Informal document **GRSP-55-08**
(55th GRSP, 19-25 May 2014,
agenda item **18**)

**Proposal of amendments to
ECE/TRANS/WP.29/GRSP/2014/7 – Draft 01 series of
amendment to Regulation No. 129**

The text reproduced below was prepared by the expert from France to introduce all the modifications needed in UN Regulation No. 129 (Enhanced Child Restraint System (ECRS)) that were suggested by the experts of the informal working group on Child Restraint Systems (IWG CRS) to extend the scope of this Regulation to Non-Integral child restraint systems ("Universal Booster" or "Specific to vehicle Booster") (Phase 2 of the UN Regulation). The modifications to the text of the UN Regulation (including ECE/TRANS/WP.29/2013/110) are marked in bold for new or strikethrough for deleted characters. **It includes and tracks latest proposal of modifications done during the two last meetings of the IWG CRS.**

Door panel geometry – Side view (Tolerance general: ± 2 mm and ± 1 degree)

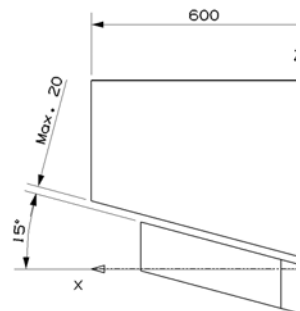
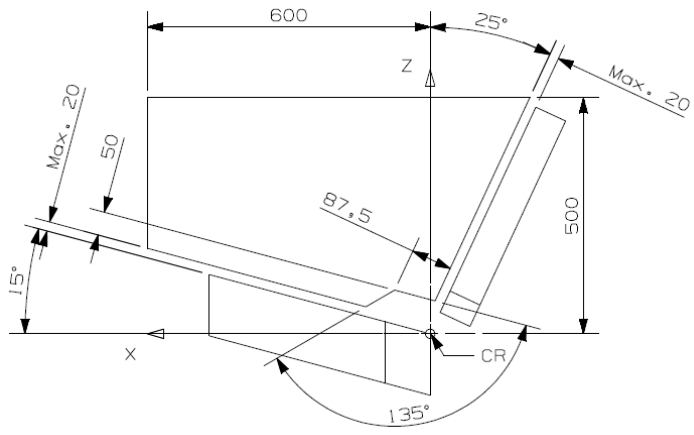
Deleted: Figure 2 .
Door panel geometry – Side view¶
<object>
